GROWTH MANAGEMENT DEPARTMENT STAFF REPORT
PONTE VEDRA OVERLAY DISTRICT
May 1, 2024 Special Public Meeting
ARC 2024-04 Golf Club Patio Renovation (Ponte Vedra Inn & Club)

To: Architectural Review Committee
Staff: Amanda Rose, Senior Planner | Brandon Tirado, Planner
Date: April 22, 2024

Summary of Request: Applicant is requesting design approval to remove an existing wooden pergola and renovate the exterior of the Golf Club Patio. Proposed changes include 1,200 square feet of concrete pavers and other impervious surfaces, construction of an outdoor fireplace, renovations to the existing wood deck, and installation of new landscaping, irrigation, and one (1) new exterior door, located at 35 Pablo Dr. within the Ponte Vedra Inn and Club. Lighting updates are also proposed. The applicant is also requesting approval for a potential canopy fabric replacement (e.g. “add alternate”). The applicant has confirmed they will be providing physical color/material samples for the Board to review at the hearing.

Figures 4A-C: Fireplace Elevations and Materials, as provided by the applicant.

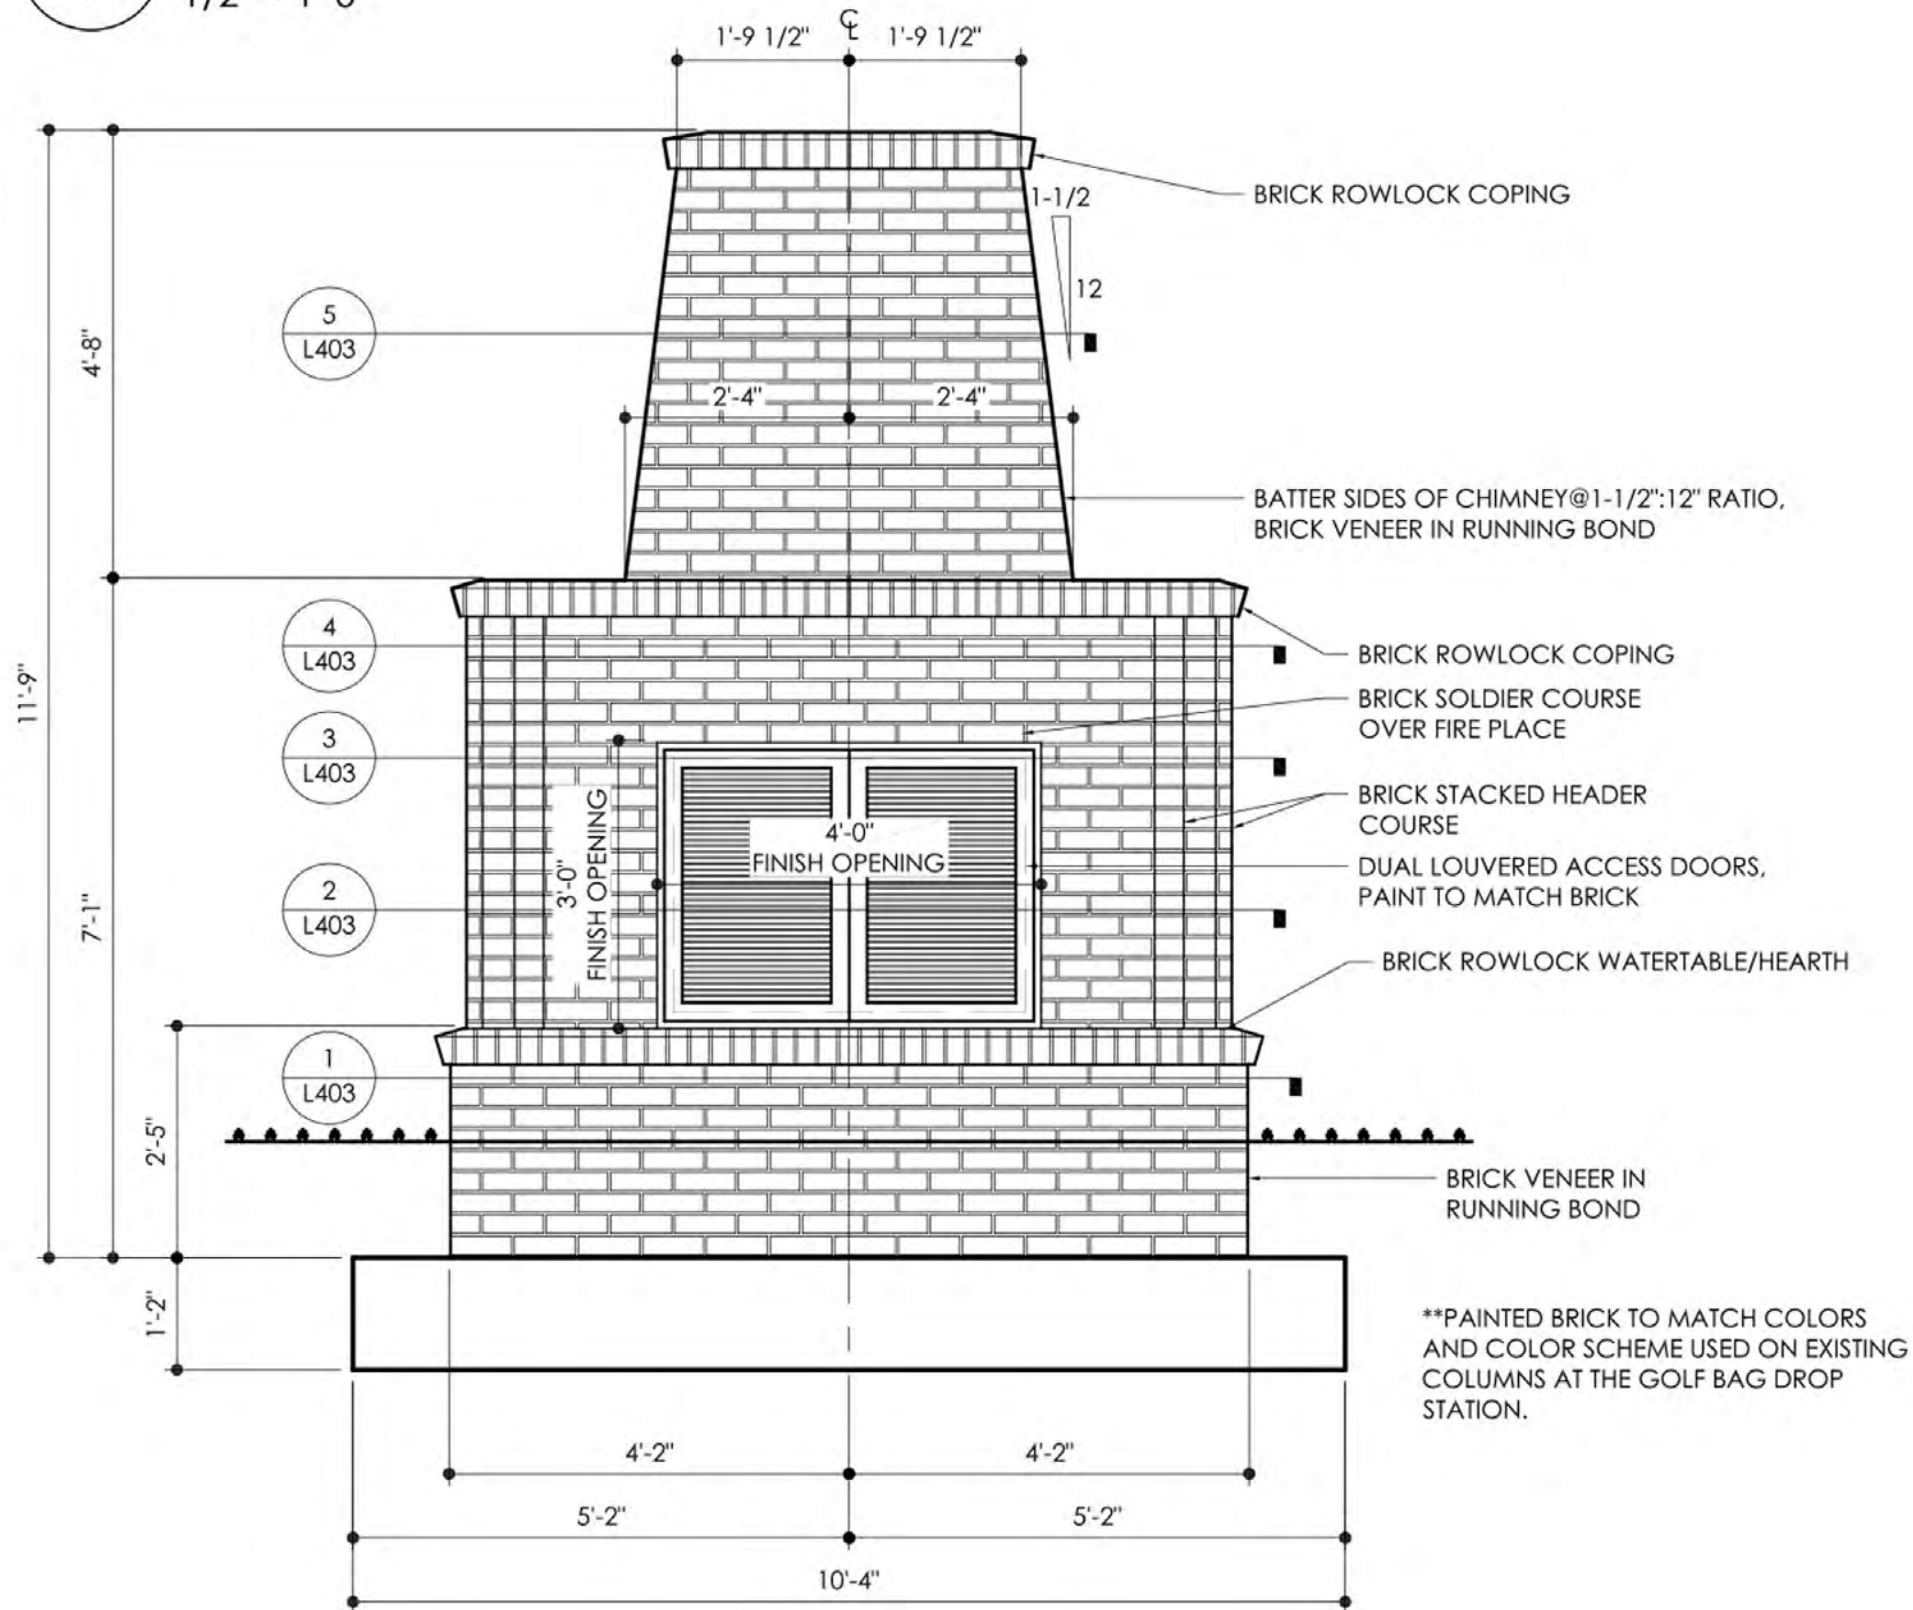
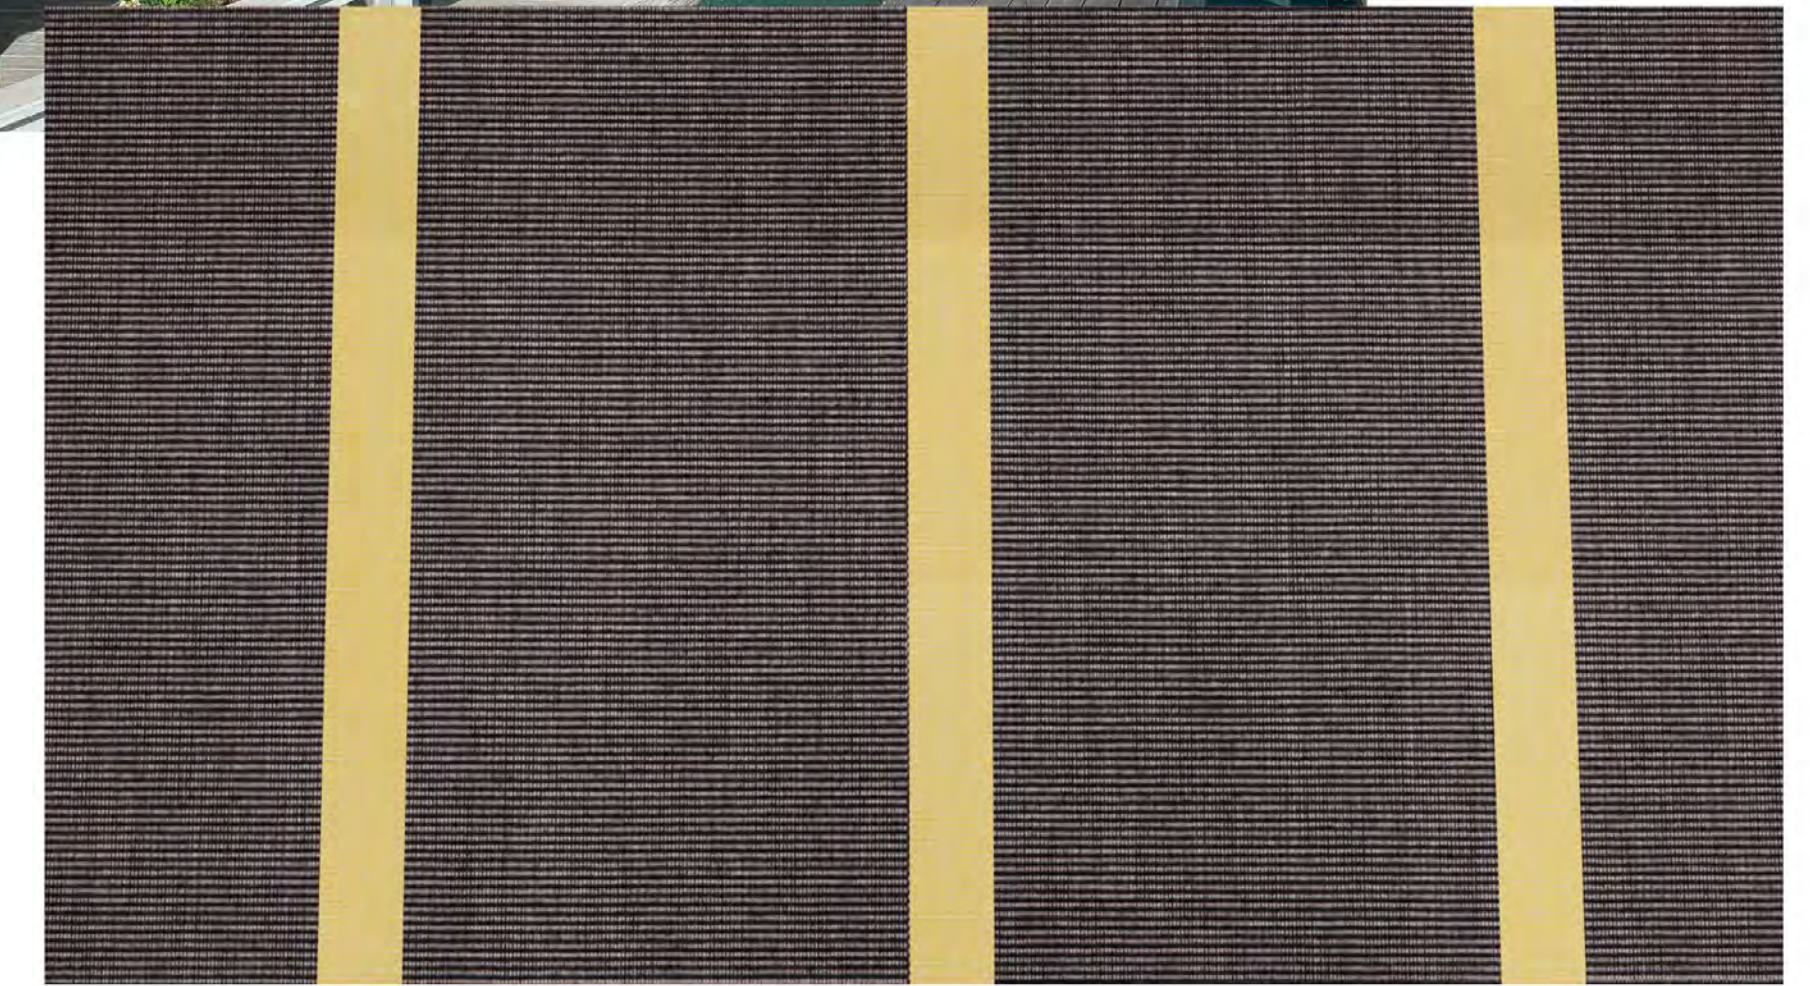
***Fireplace (See Figures 4A-C)**—The applicant proposes to paint the outdoor fireplace white to match the existing columns at the golf drop-off (see Figure 4C), and it is also noted that all paint colors used for the building, doors, and modifications to the wood deck will match the existing colors. The colors and materials of the proposed fireplace appear to be consistent with Section VIII.Q.5(d) Architectural Design Standards and Section VIII.Q.5(e). Design Elements and Materials of the PVZDR. The proposed design and color appear subdued and compatible with the existing Golf Club elements as well as with the overall expectations of the Ponte Vedra Overlay District.
